## ADDENDUM # 2

Project: **NEWBERRY MUSEUM** with bids previously due not later than 3:00 PM, January 25, 2018 but as of this addendum with a **revised bid date of January 30, 3:00 PM.**

Date of this addendum: **January 18, 2018**

SITE LAYOUT  
 Bulletin Drawing  
 BDC001

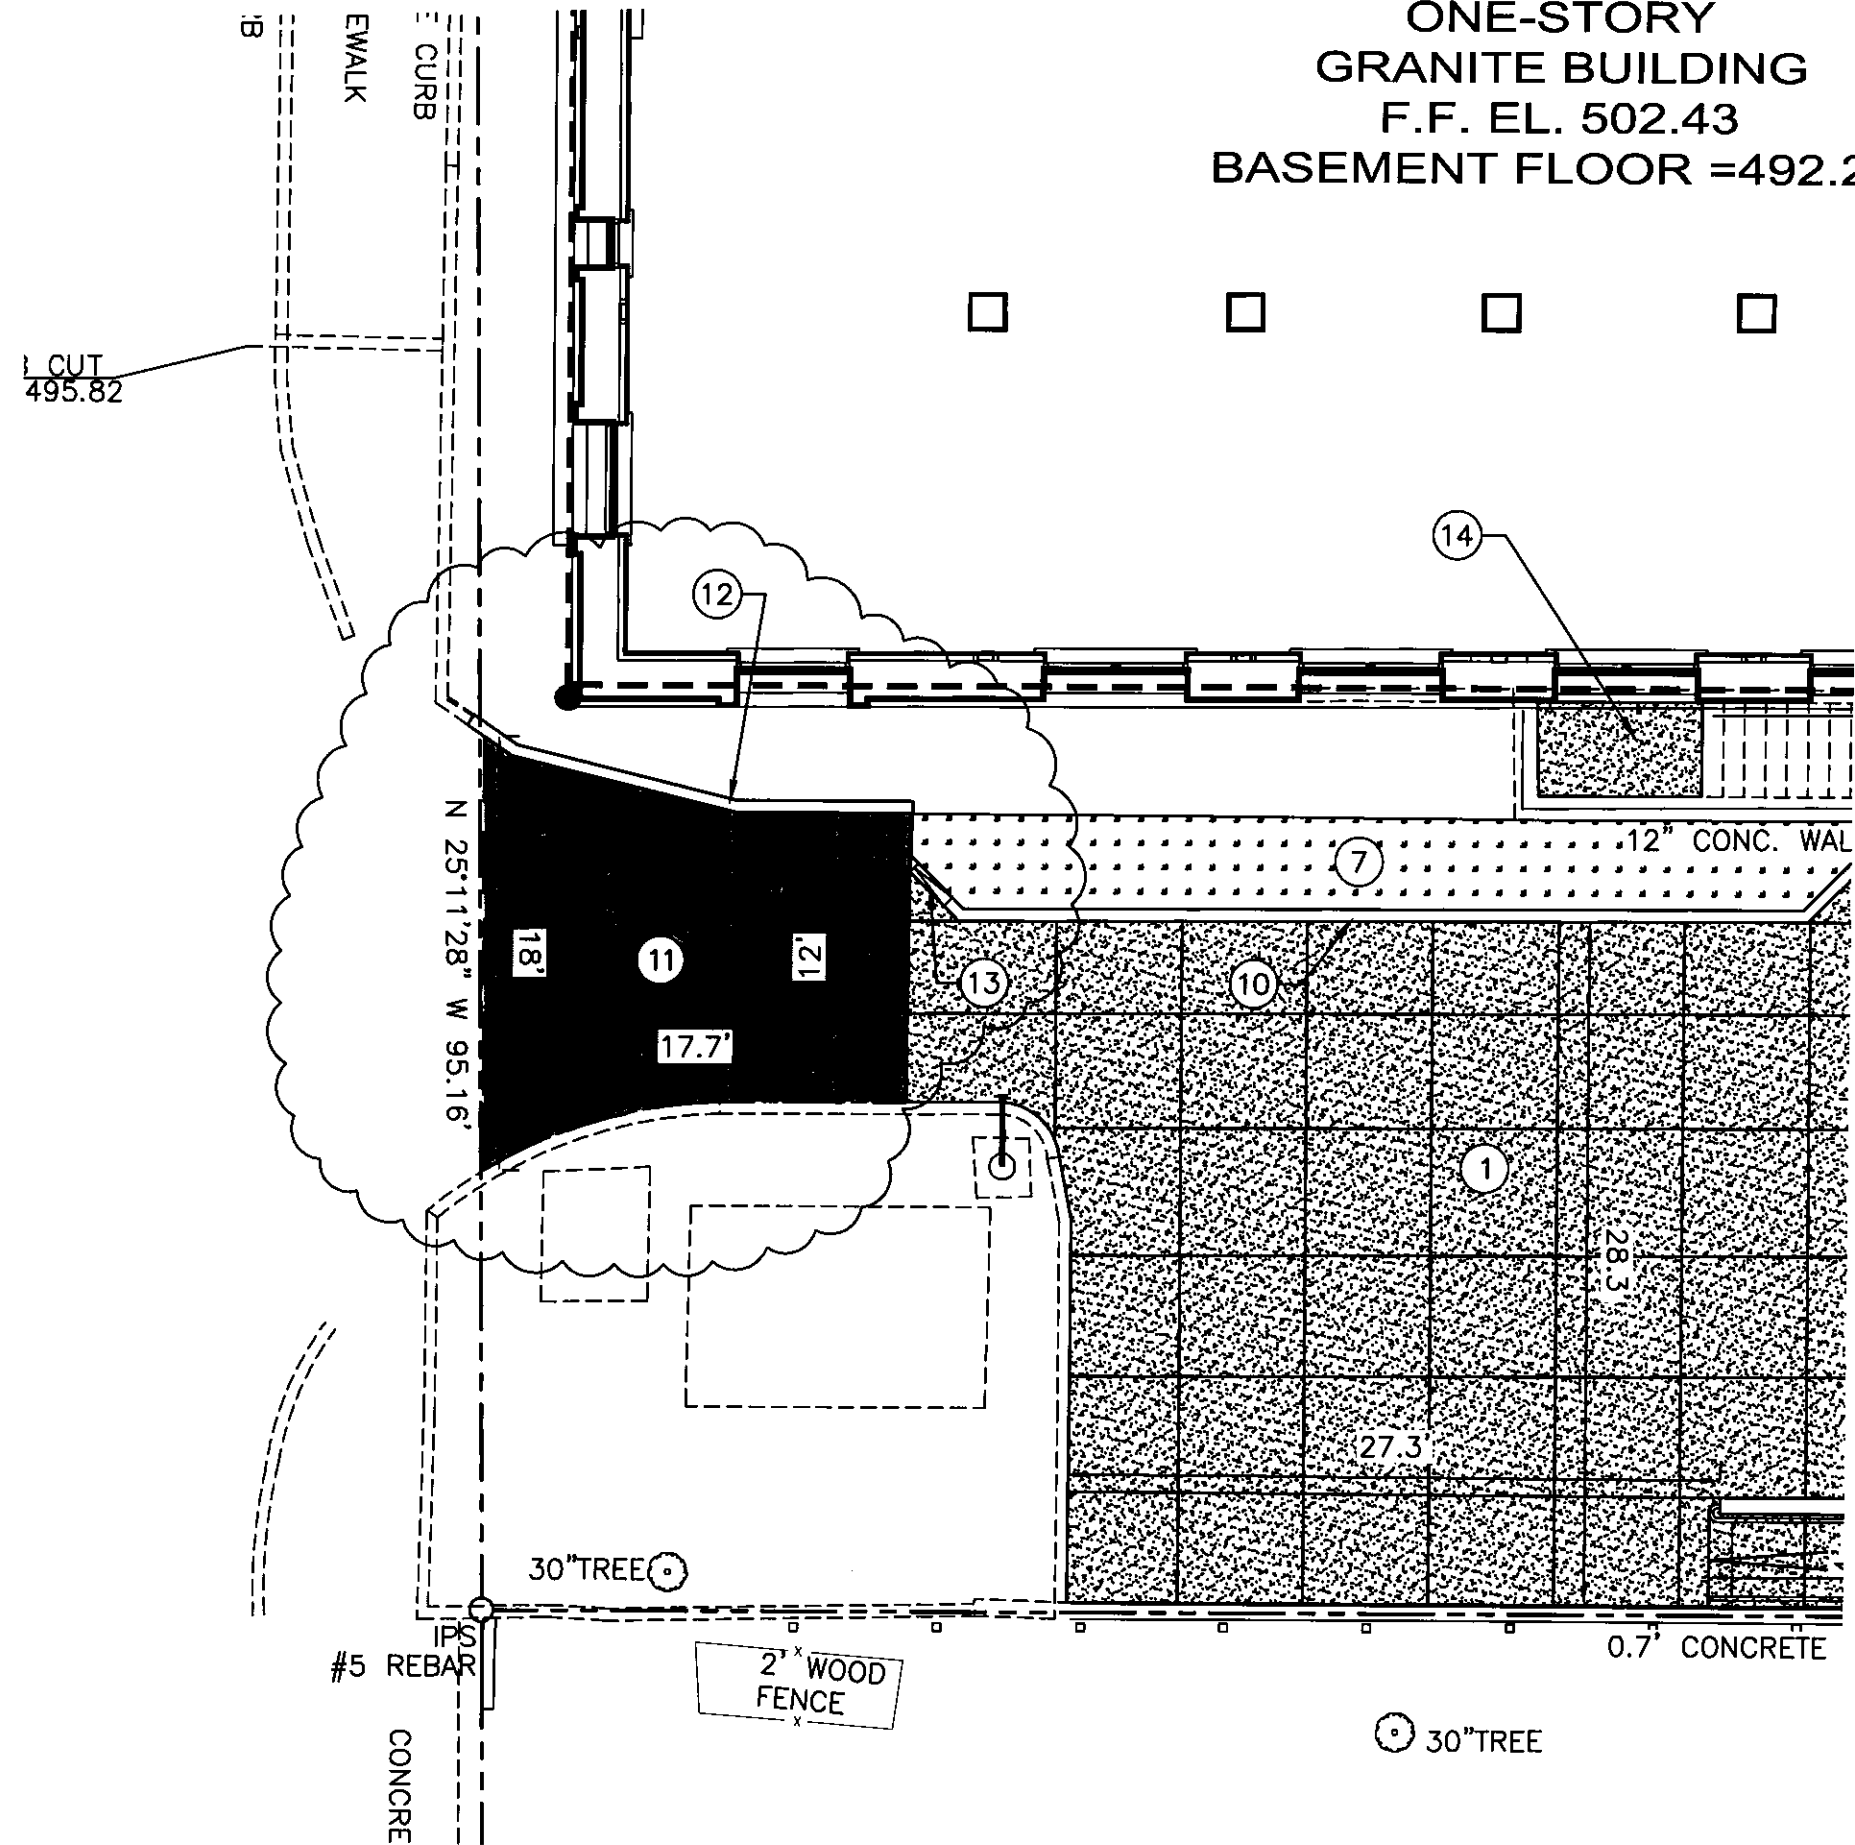
1. Add the following Bulletin Drawings as changes to Civil Plans, sheets C2.0 & C3.0:
  - a. **Addndm2.Exh S.17564-BDC001.pdf** addresses the requirement to remove and replace a portion of the concrete driveway and curb at the College Street Driveway. Electrical utility routing is to cross below the driveway, and therefore new Heavy Duty Concrete pavement and concrete curb are to be installed as shown.

SITE LAYOUT  
 Bulletin Drawing  
 BDC002

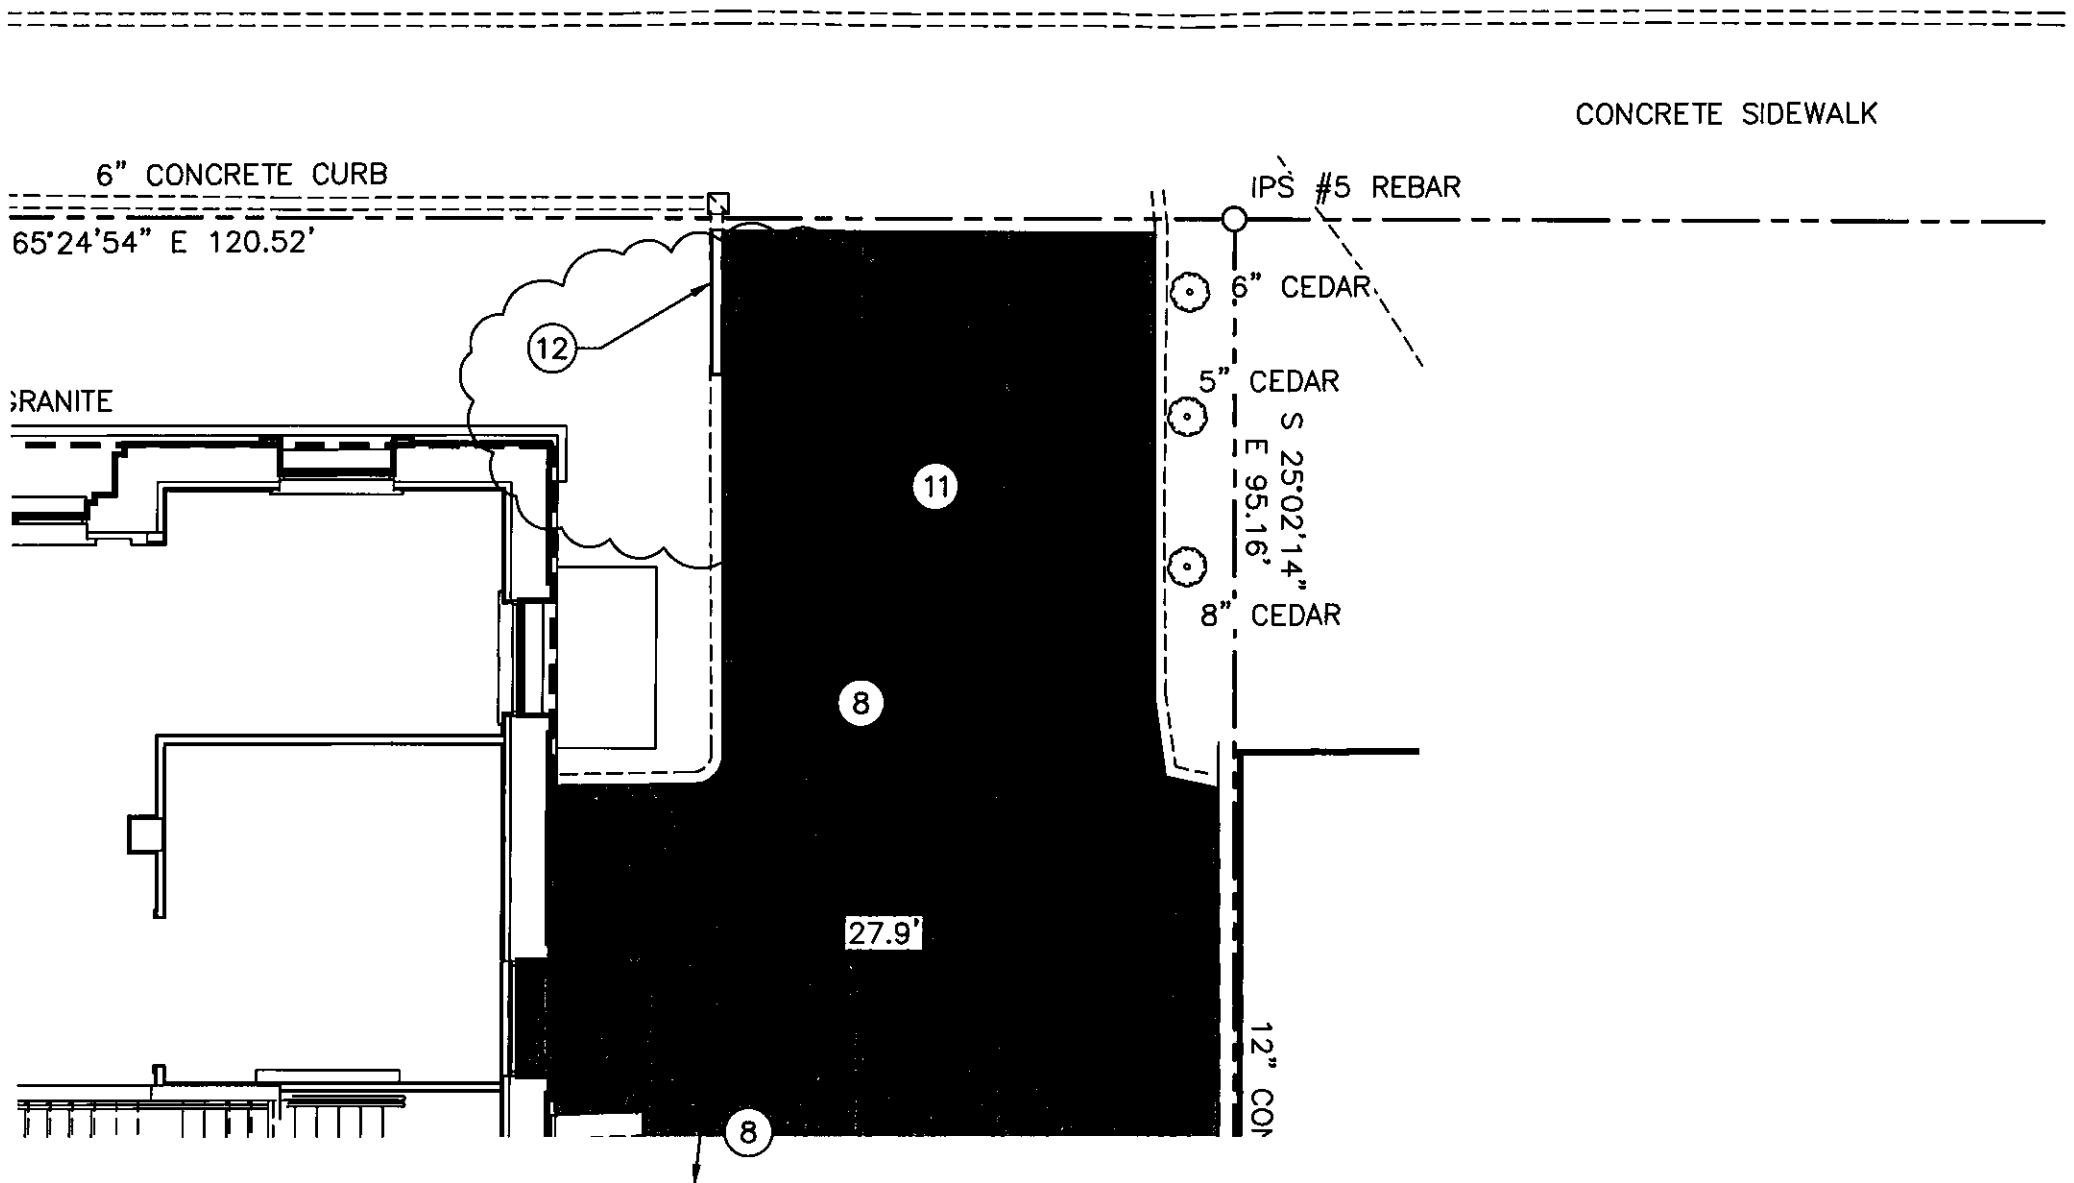
- b. **Addndm2.Exh T.17564-BDC002.pdf** adds KEY NOTES numbers 11 and 12, as keyed on sheet C2.0 and refers to paving and curbing types.
2. Substitute the following revised architectural drawings with information on basement waterproofing:

4 WINDOW WELL DETAIL  
A5.2 SCALE: 1/2" = 1' - 0"

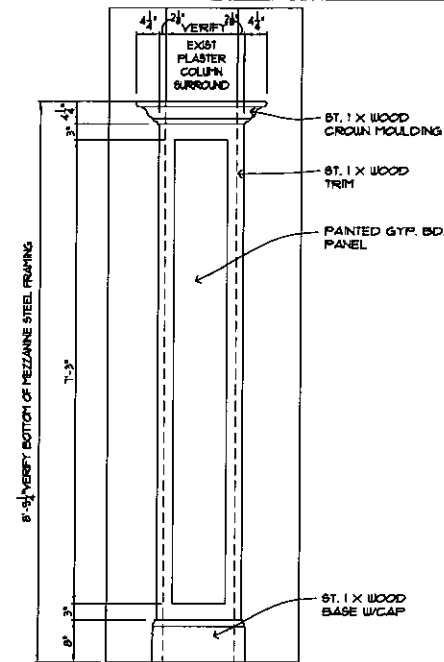
- a. **Addndm2.Exh U.A5.2-180118.pdf** showing waterproofing at infilled window wells.
  - b. **Addndm2.Exh V.A5.3-180118.pdf** showing waterproofing of basement elevator shaft and footing.

PRECAST STEPS DETAIL

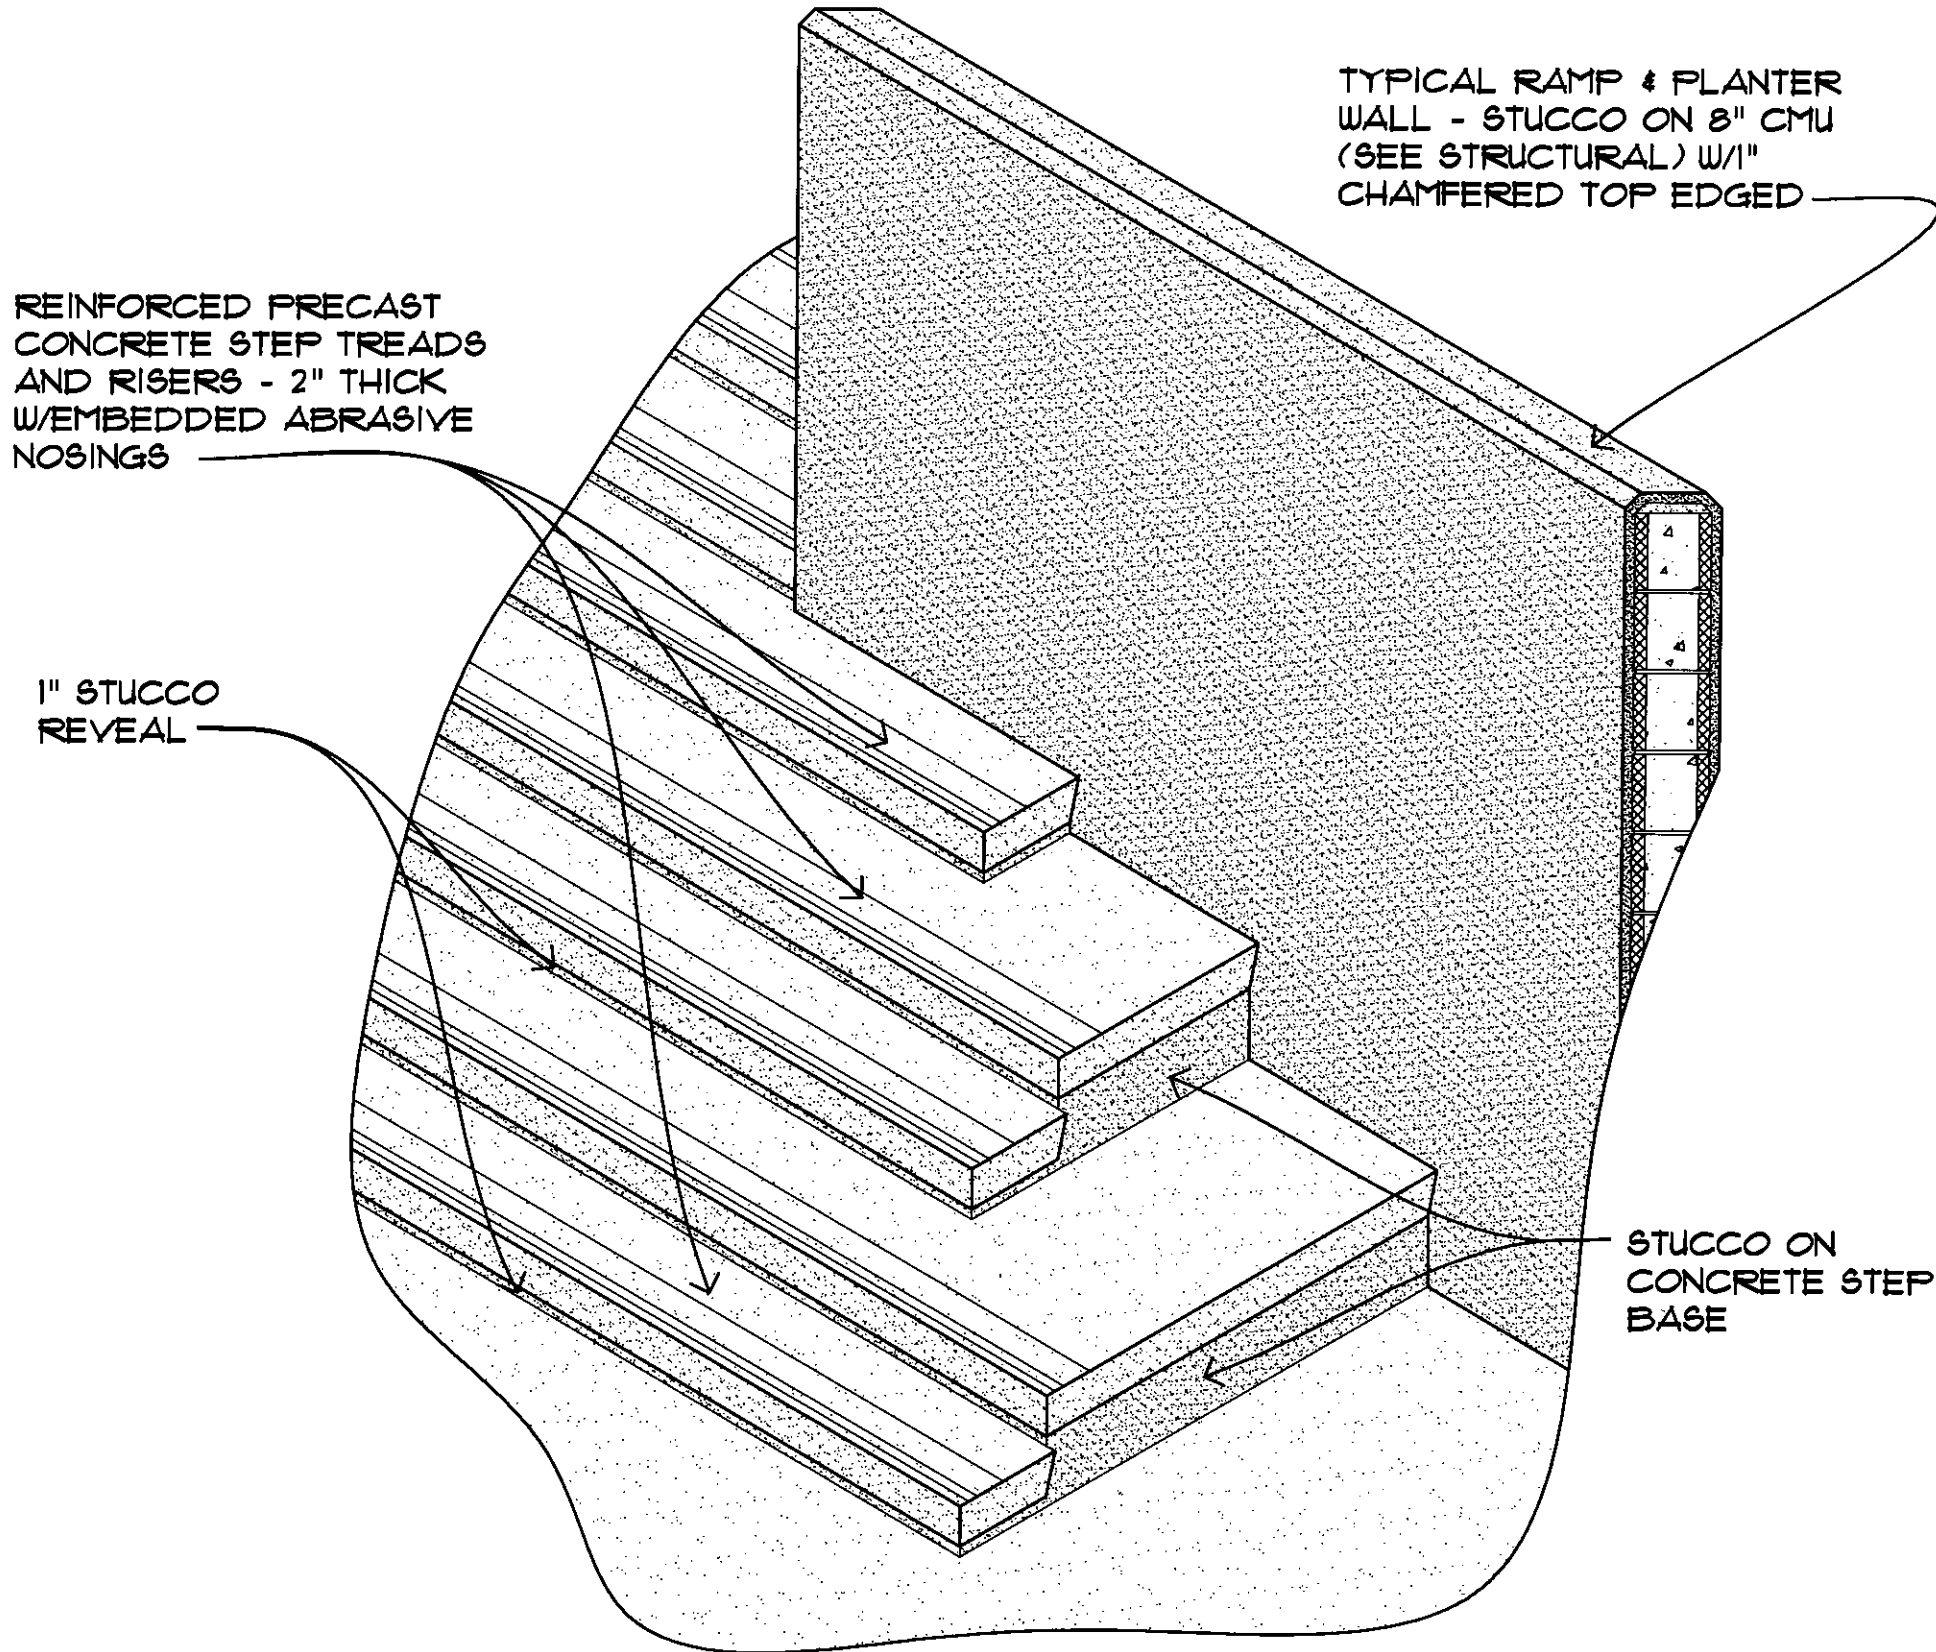
- a. **Addndm2.Exh W.BDA001.pdf** and **Addndm2.Exh X.BDA002.pdf** showing exterior precast steps and stucco-covered CMU retaining walls.
4. Supplement Structural drawing S4.1 with helical reinforcing piers for the existing foundation near elevator:
  - a. **Addndm2.Exh Y.BDS001.pdf** showing helical piers in section.
  - b. **Addndm2.Exh Z.BDS002.pdf** containing notes about the helical piers.
5. Electrical sheet E1.1: The four (4) Type Z4 light fixtures and circuiting originally designated as Add Alternate #4 shall be revised to include a note about the lights as follows: **"TO BE INCLUDED AS PART OF BASE BID."** This revision will eliminate Add Alternate #4.
